ADDENDUM NO. 03

Project Name: Aston Township Municipal Complex

Project No.: 2301.00-22

Date of Issue: April 18, 2024

Sheet Number:
SD-A06

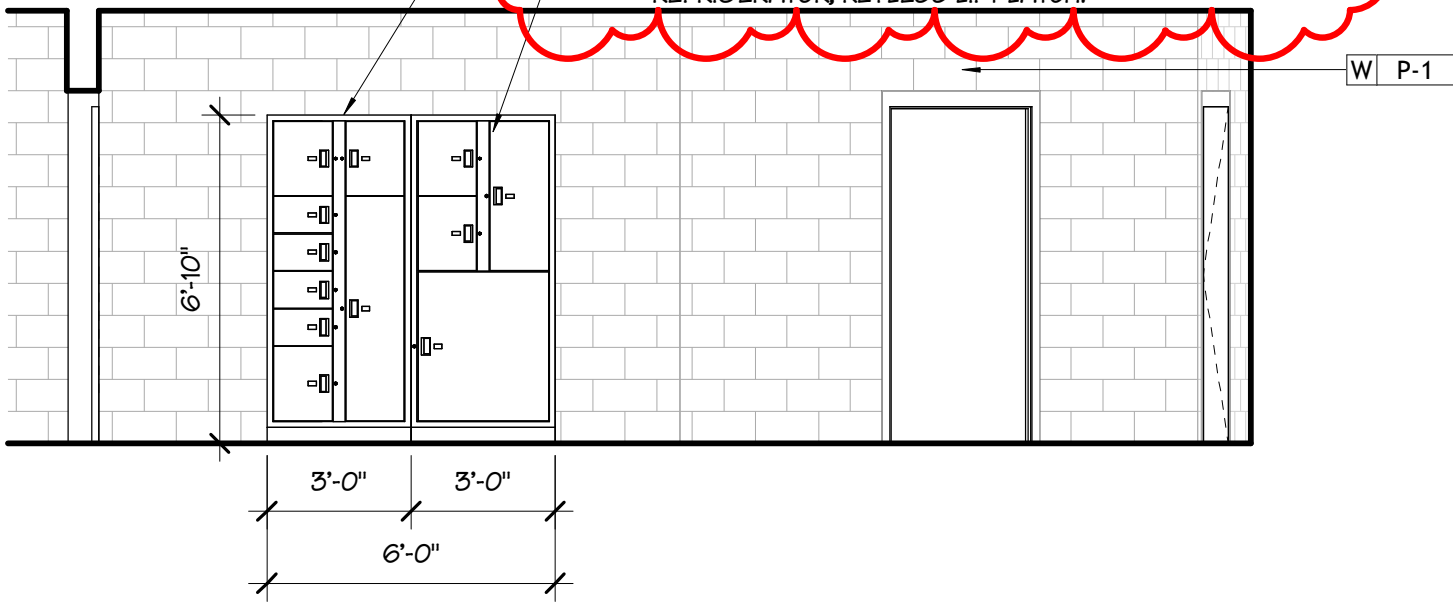
5. Reference to Sheet A-513 – Police Station - Enlarged Plans and Elevations; Drawing 10/A-513: Supplemental drawing SD-A06 - Evidence Recording 130 – Elevation is included as part of this addendum, and it reflects an adjustment to the fume hood linework. The Fume Hood is a part of the contract, and it is specified in Section 115313 - Laboratory Fume Hoods.

BASIS OF DESIGN PRODUCT:
STEELE SOLUTIONS; TIFFIN EVIDENCE LOCKER. PROVIDE
EVIDENCE LOCKER CONFIGURATION 08AD; KEYLESS
LIFT LATCH

BASIS OF DESIGN PRODUCT
STEELE SOLUTIONS; TIFFIN EVIDENCE LOCKER. PROVIDE
REFRIGERATED EVIDENCE LOCKER CONFIGURATION
04AE_R WITH 4-DOOR REGULAR INSERT IN
REFRIGERATOR; KEYLESS LIFT LATCH.

Sheet Number:
SD-A05

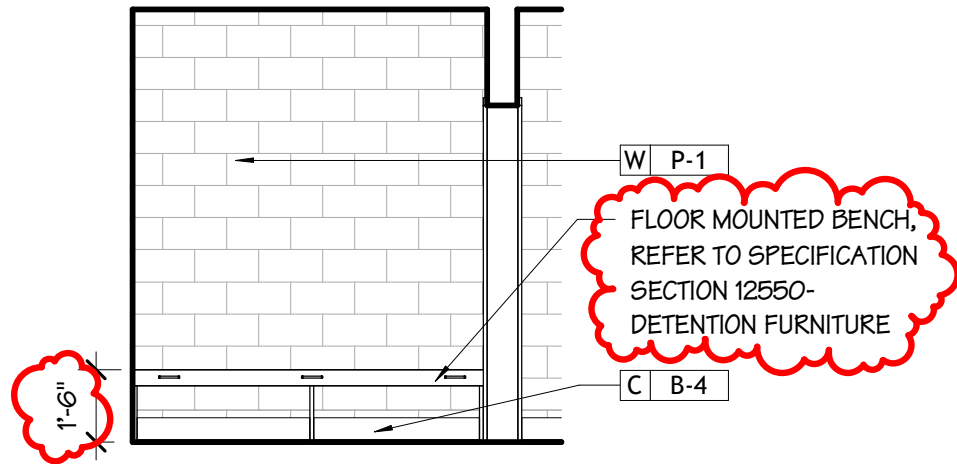
4. Reference to Sheet A-513 – Police Station - Enlarged Plans and Elevations; Drawing 9/A-513: Refer to supplemental drawing SD-A05 - Evidence Recording 130 – Elevation, included as part of this addendum, for evidence storage locker requirements.

REORGANIZED DETAILS TO ELIMINATE
SHEETS P-203 AND P-204

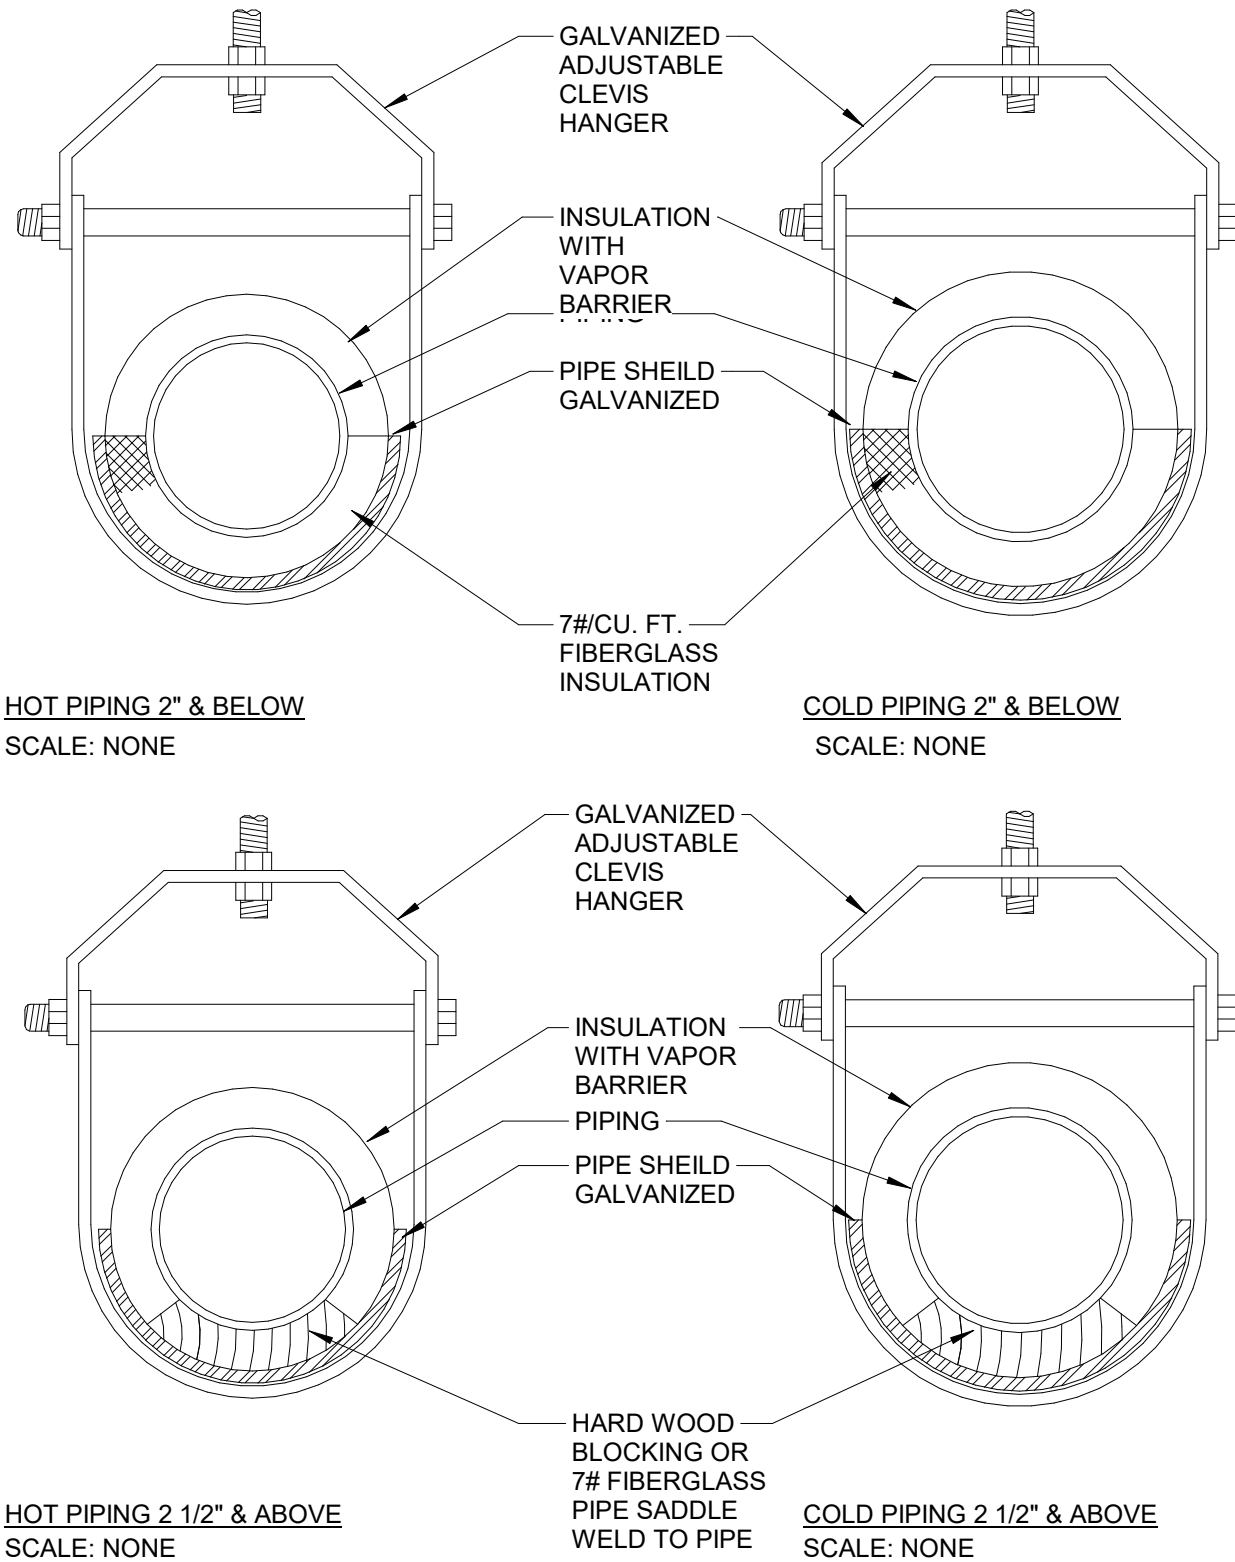
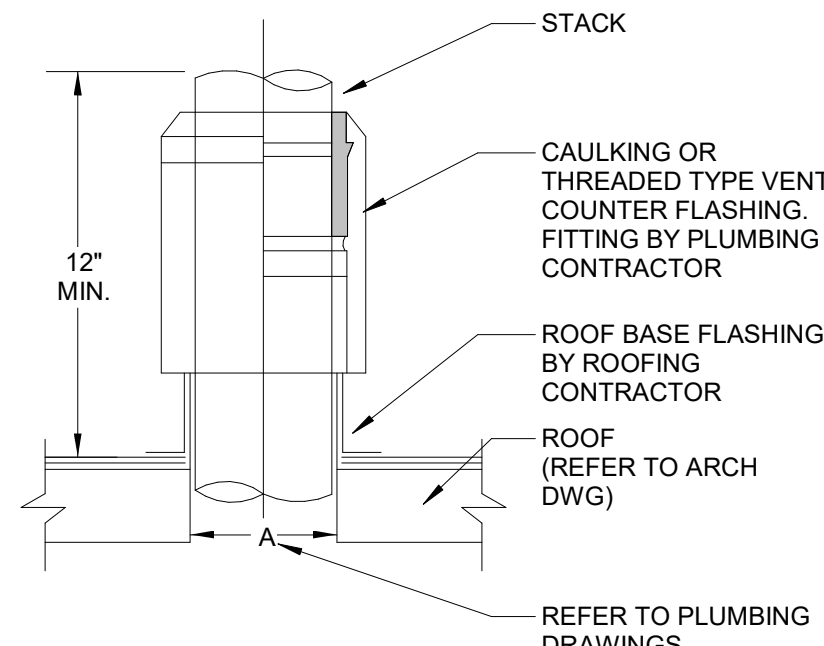
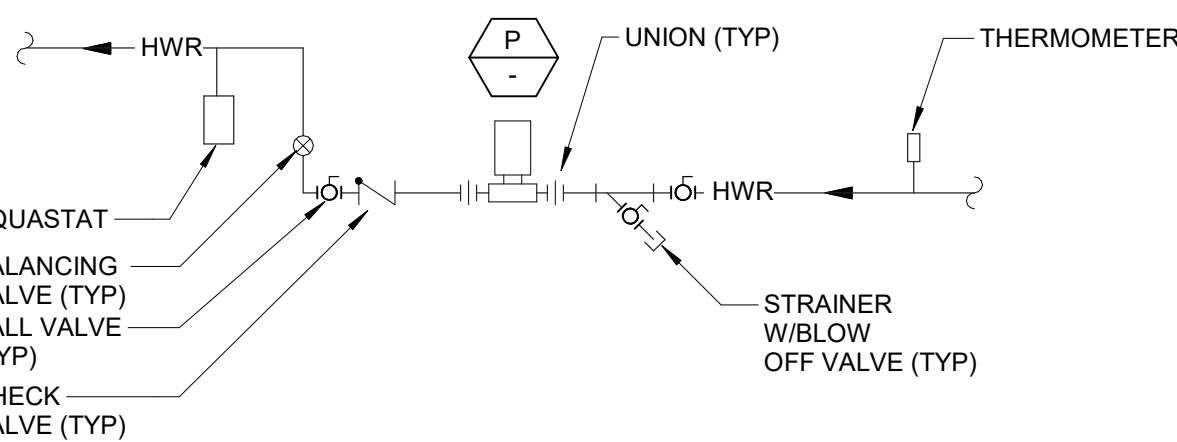
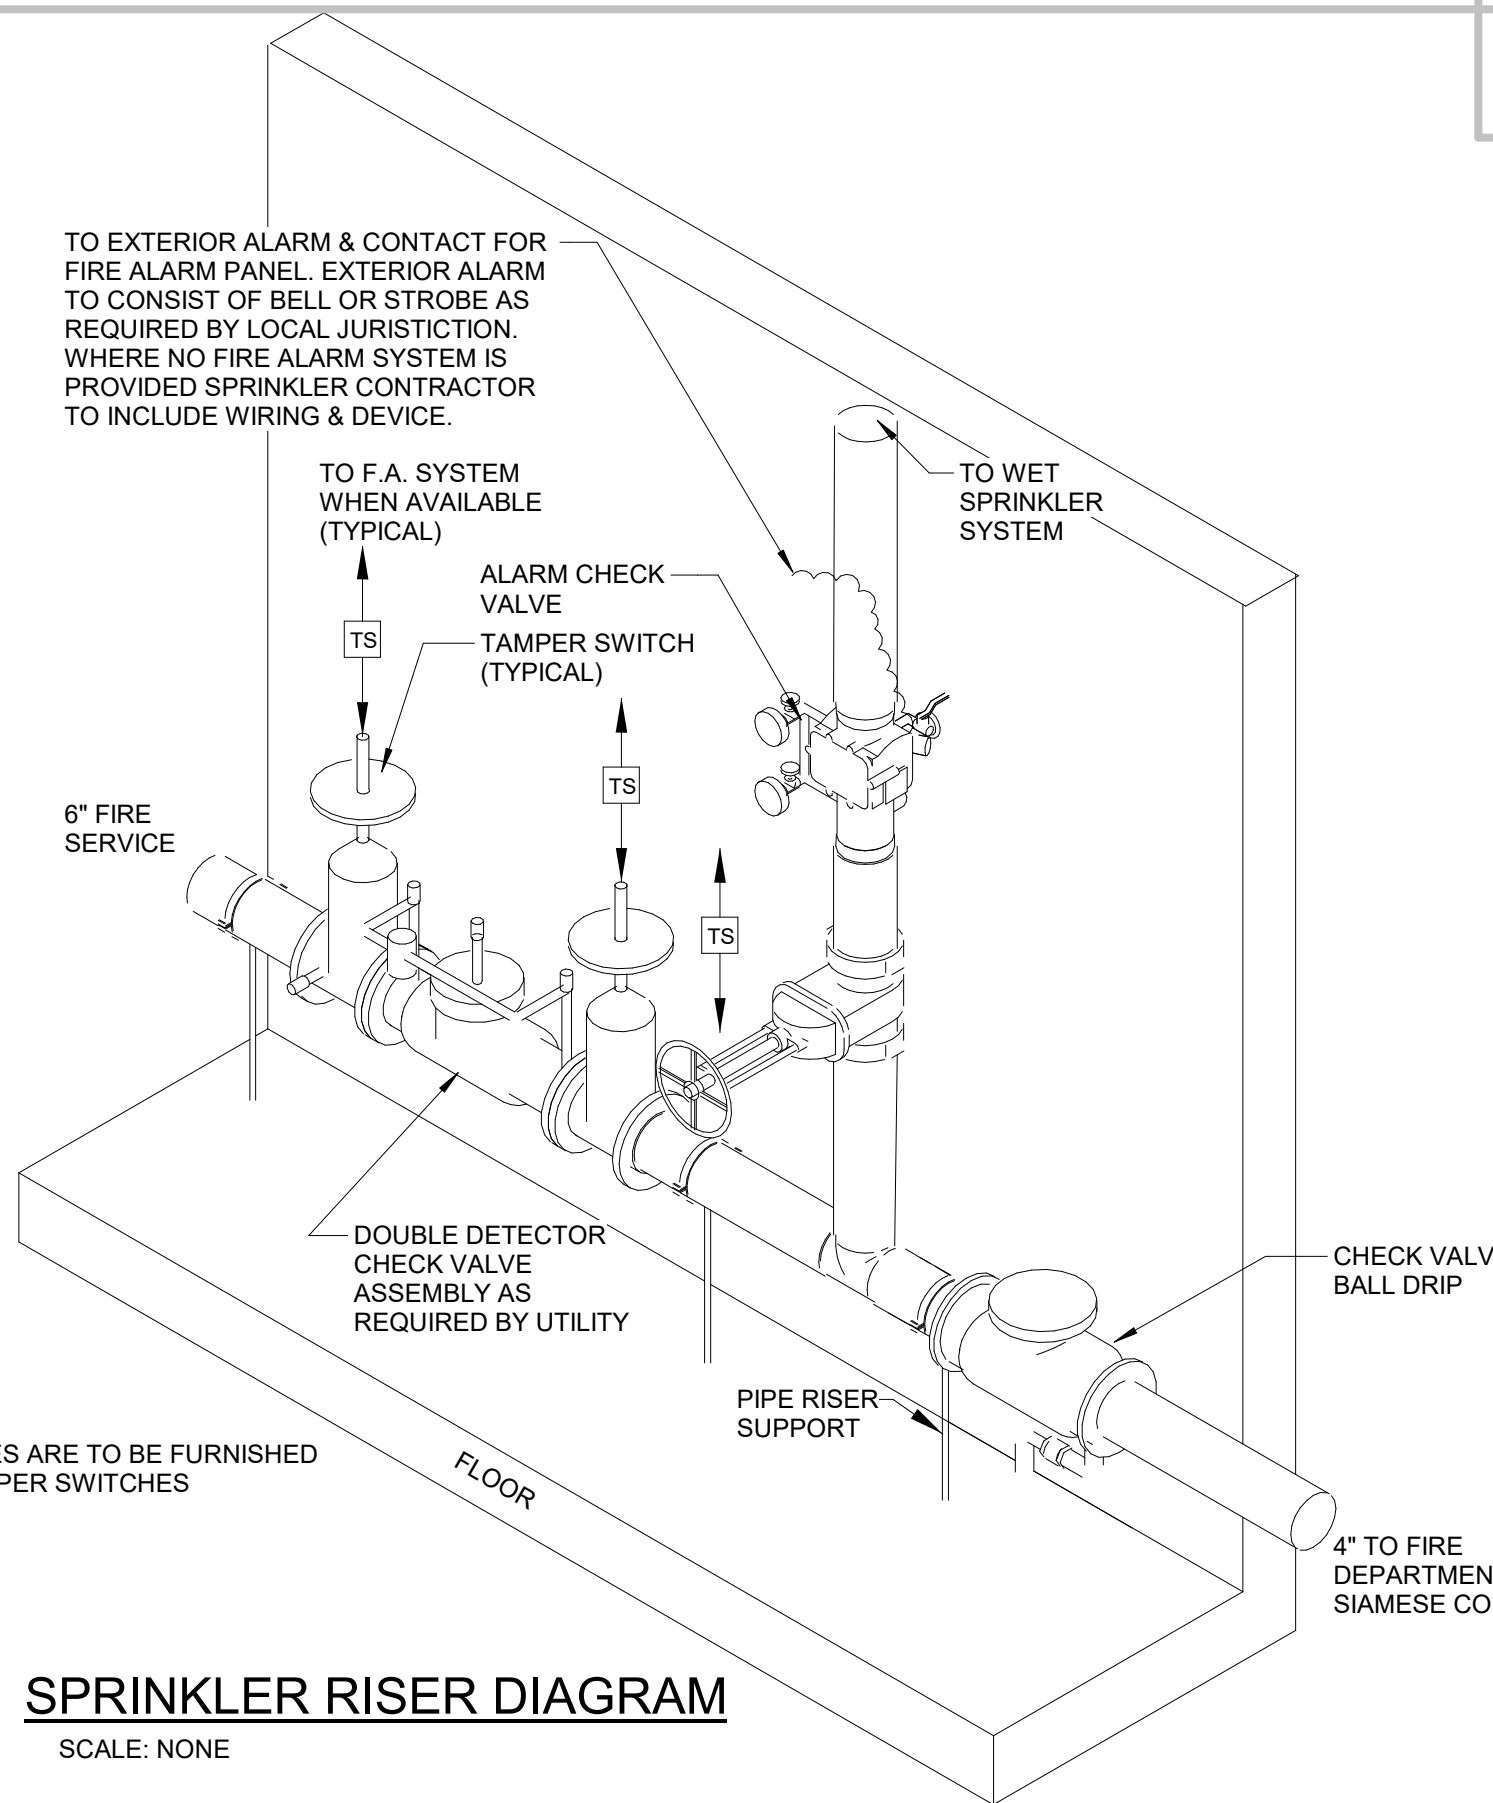
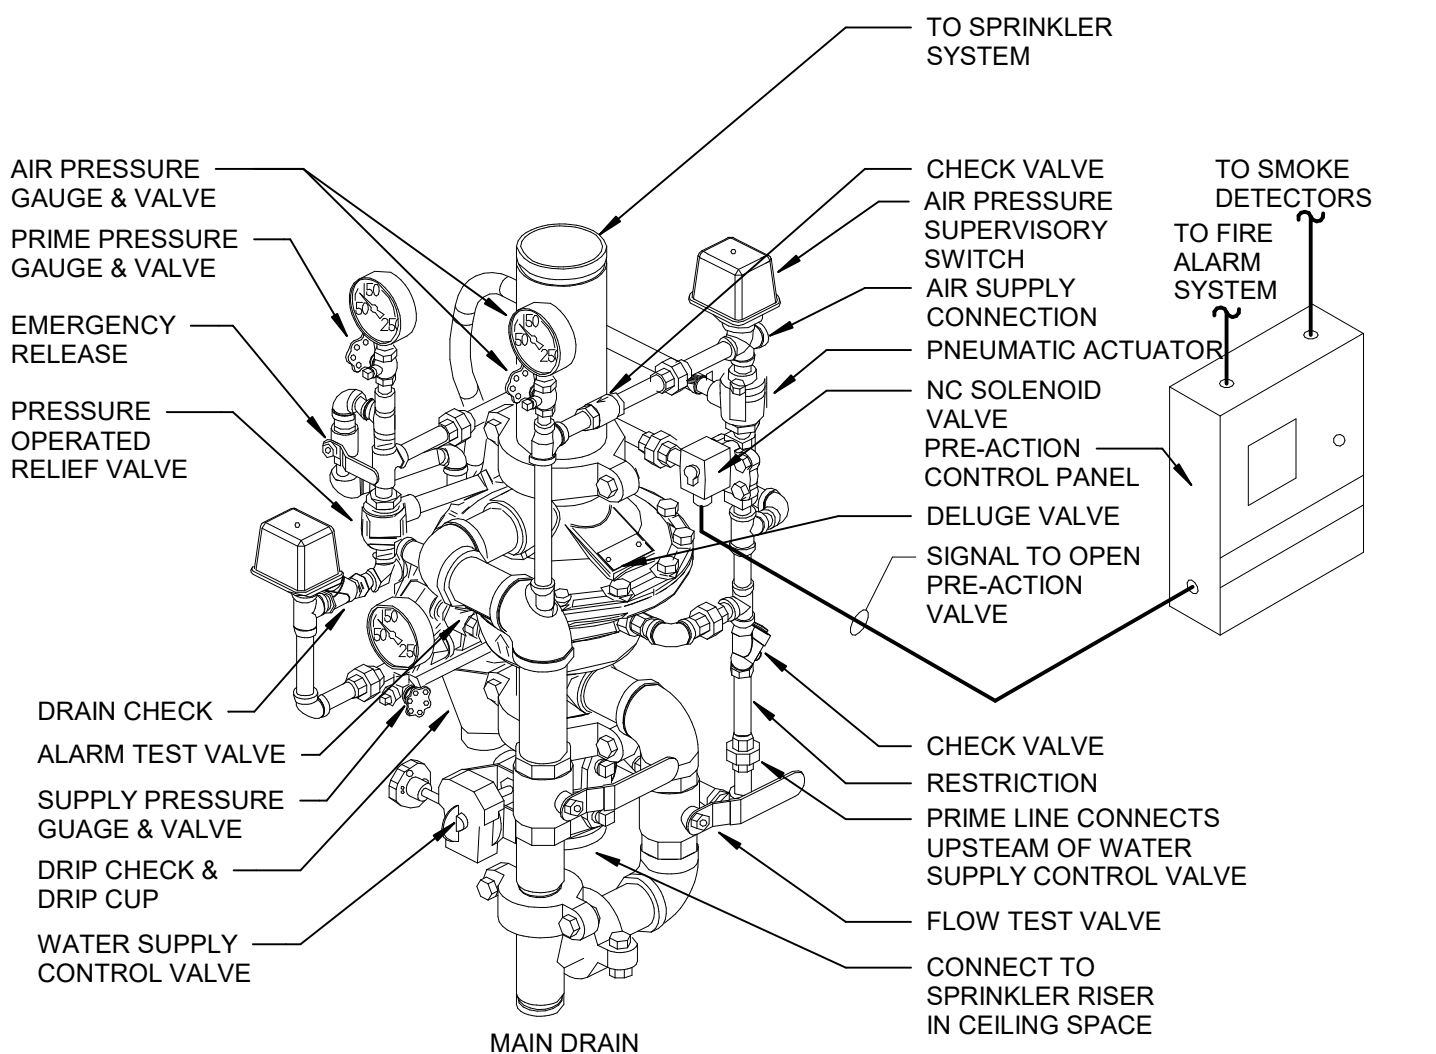
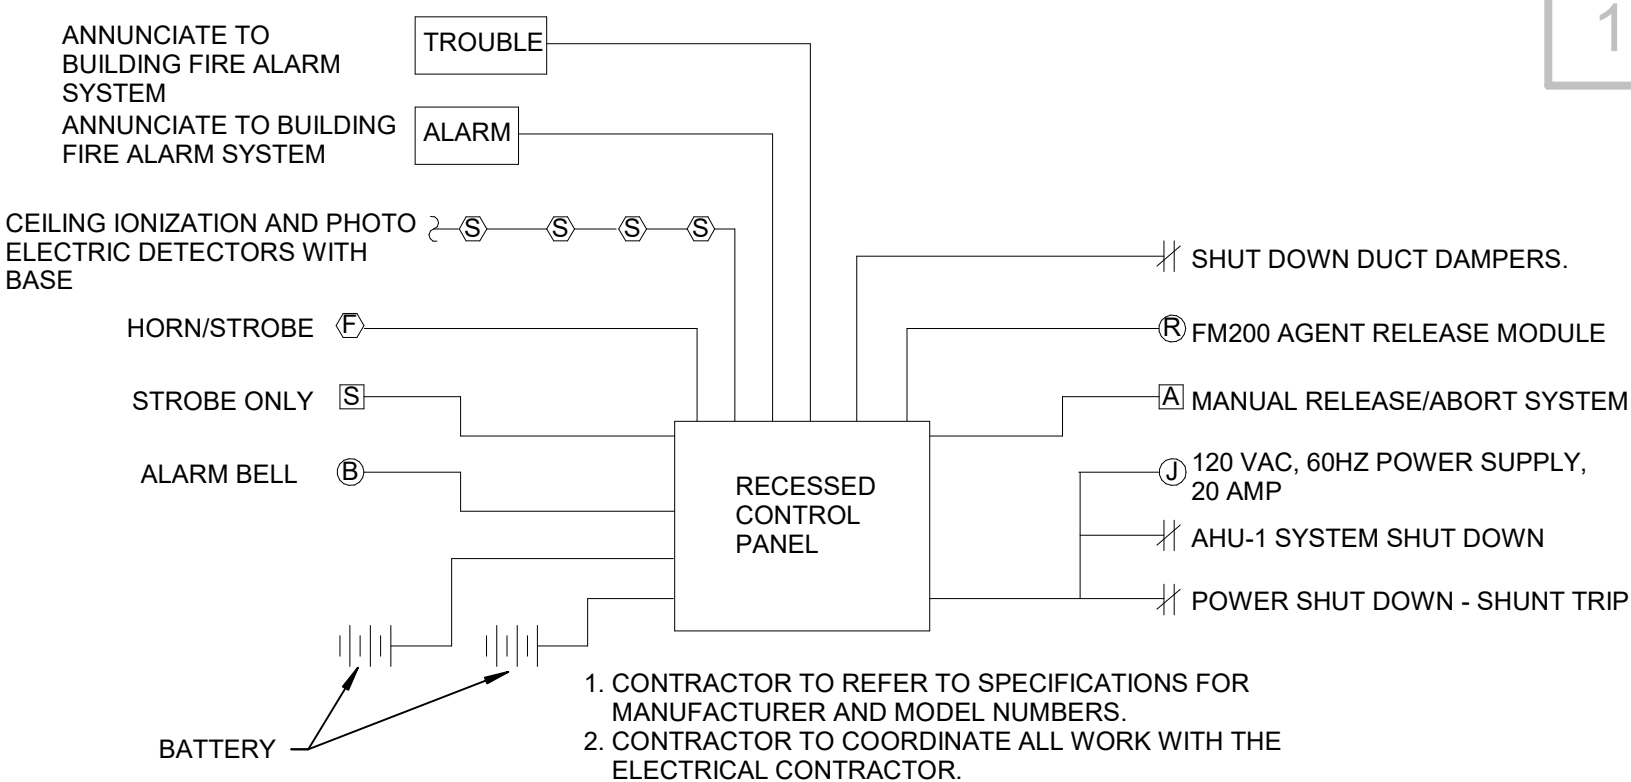
22. Reference to Sheet P-201 – Details – Plumbing: Sheet P-201 – Details – Plumbing is being reissued as part of this addendum. Details were reorganized on the sheet to allow for the elimination of other sheets in the set as noted in this addendum.
